TITLE: Pen holder tube		
SIZE <b>A</b>	UNITS: MMGS	REV 1.0
SCALE: 1:1		SHEET 1 OF 1

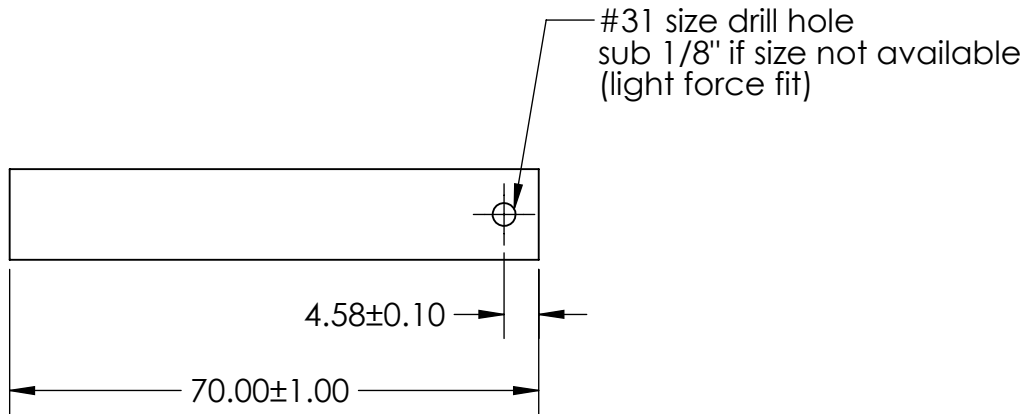
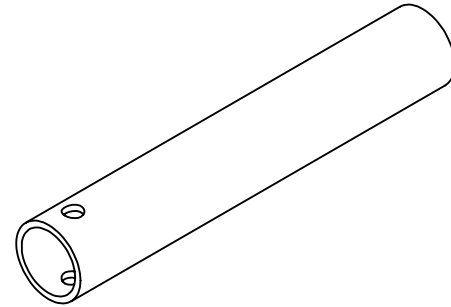
Ideally shaft will be no larger than 12mm.  
Unsure of how badly 0.08mm over  
(max tube tol) will affect linear bearing
